RE: Rochester Housing Authority,  
**Water Repellent, Concrete and Masonry Repairs**  
**University and Kennedy Towers**

ADDENDUM #1

## Addendum No. 1

re **Rochester Housing Authority**  
**Water Repellent, Masonry and Concrete Repairs**  
**University and Kennedy Towers**

A Drawing A1 - Photos, Aerials and Notes;

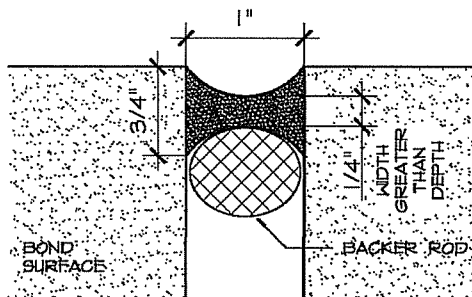
2 Sealant Joints for "Unit Quantities" and Section 01 2200 - Unit Prices shall be based on the following joint size;
